March 19, 2019

Project No. 12091-01

**Subject: Preliminary Geotechnical Evaluation and Response to City Review Comments for Proposed San Pedro Distribution Center, 1599 W. John S. Gibson Boulevard, Los Angeles, California**

***Response to Comment No. 14***

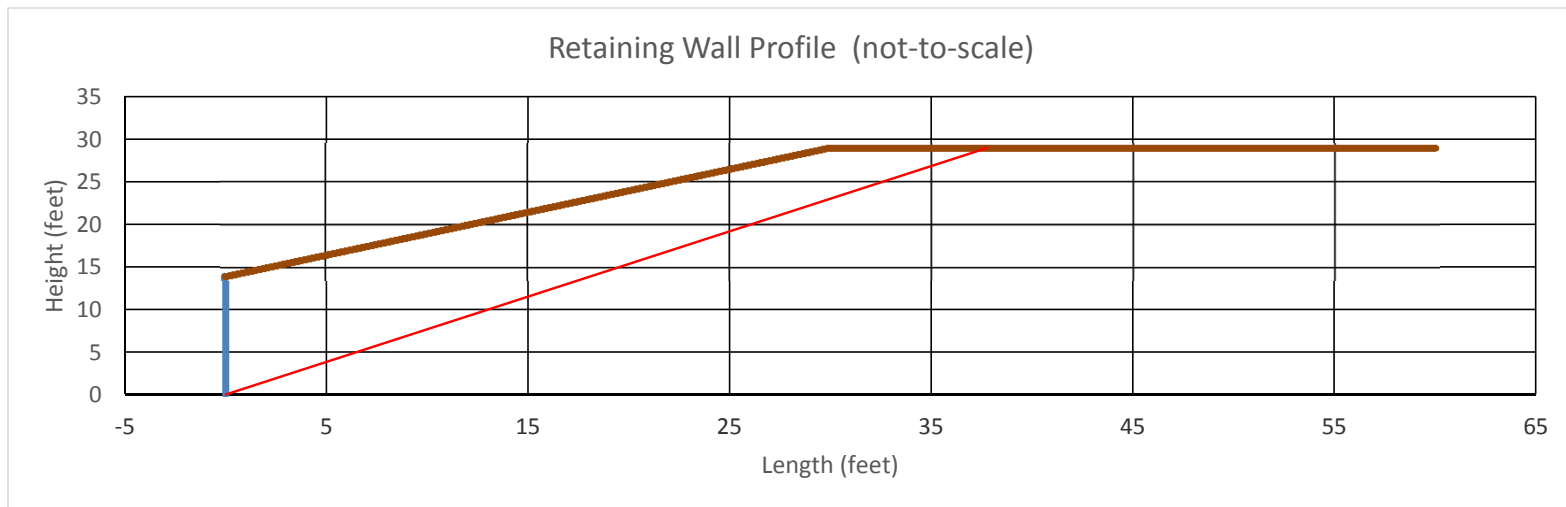
“Provide retaining wall/basement design calculations and recommendations for lateral earth pressure due to earthquake motions for walls higher than 6 feet, as required by Section 1803.5.12 of the 2017 Los Angeles Building Code.”

Seismic Parameters	
Horizontal Coefficient $k_h$	0.23

Spreadsheet Assumptions:  
 Vertical Wall (no batter), Neglect Wall Adhesion  
 When using wall friction, resultant load provided (conservative).

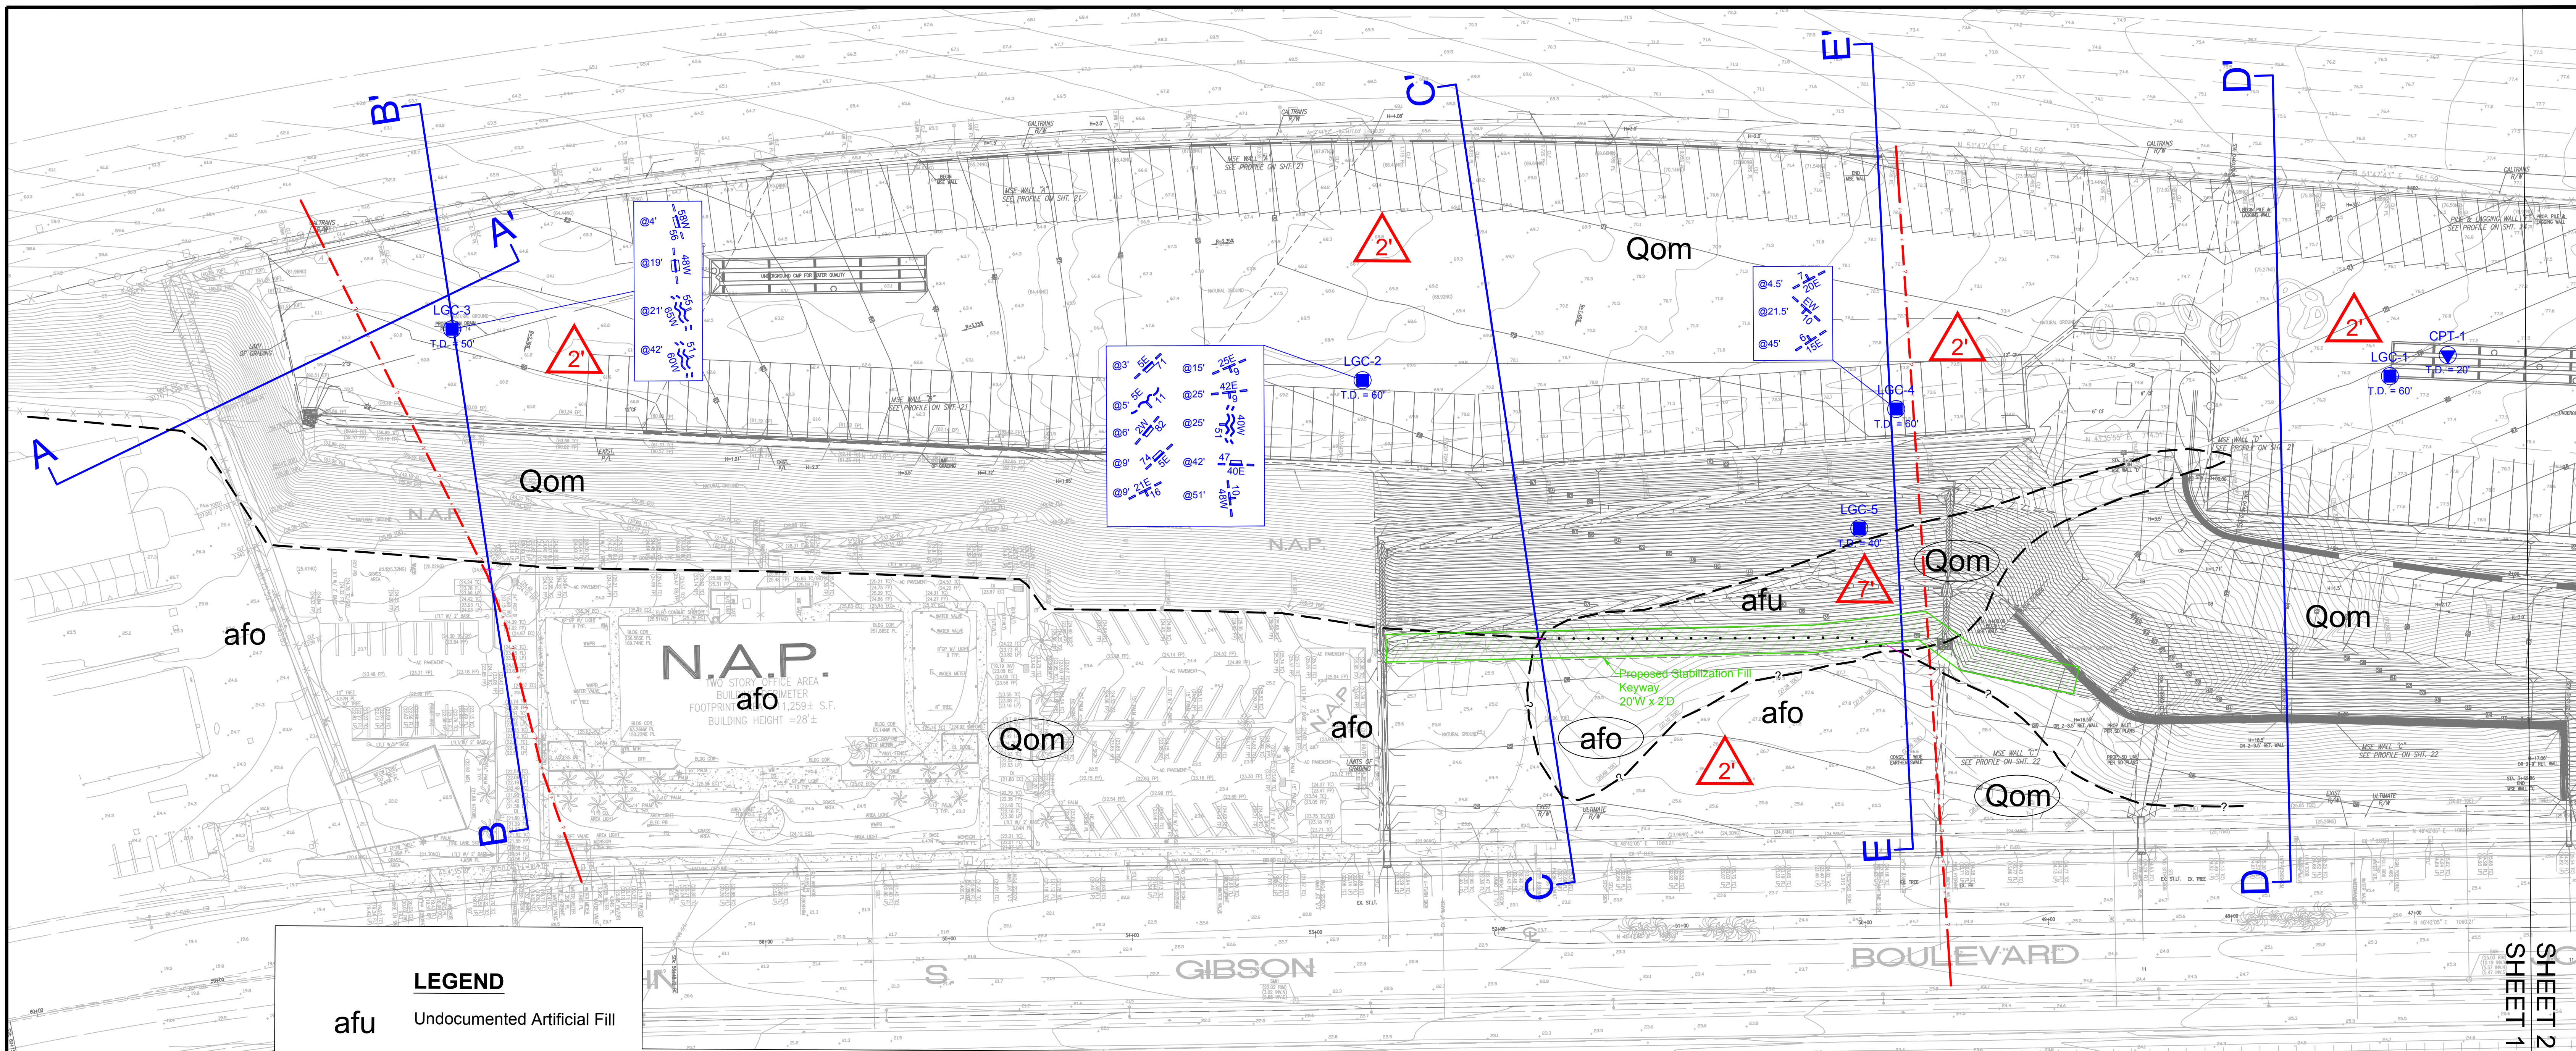
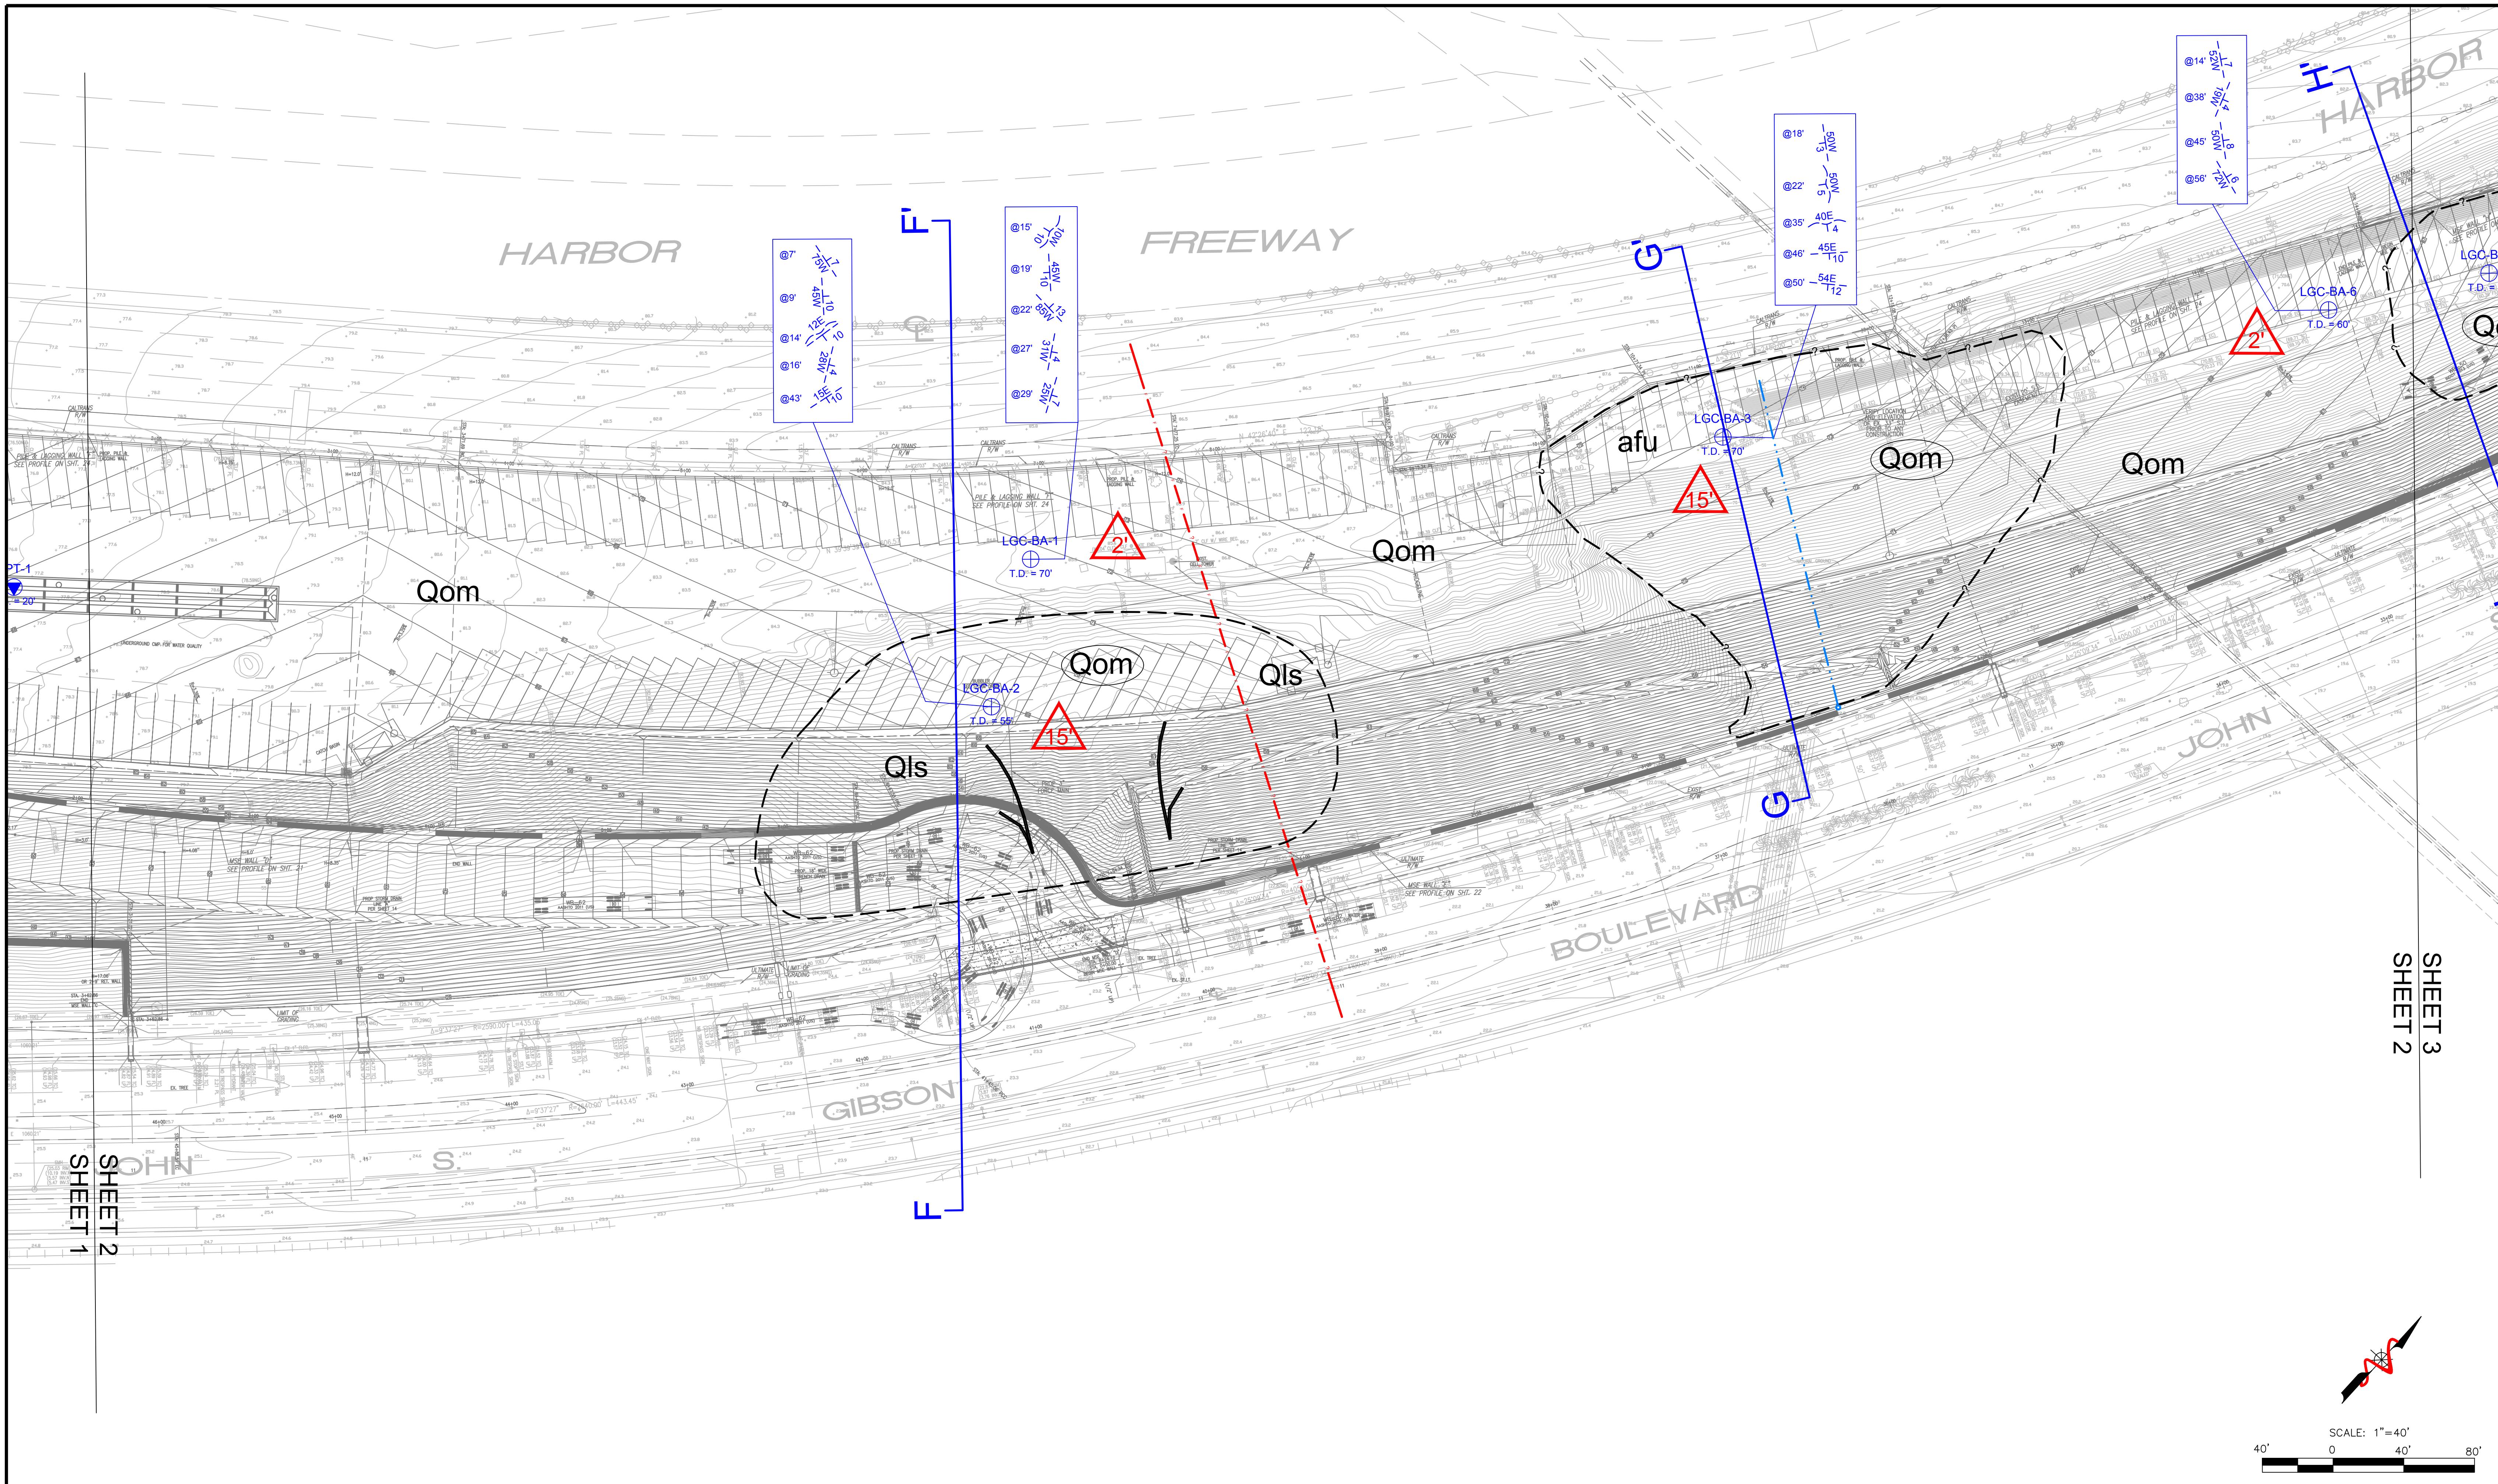
“No map was provided with the current update report reflecting the proposed site conditions. Provide recommendations and revise the plan(s) and cross sections(s) for providing the required building setback from the toe of the ascending slope as specified by Code Section 1808.7.1.”

Refer to the attached Geotechnical Map (Sheets 1 through 3). No building structures are planned for the site.
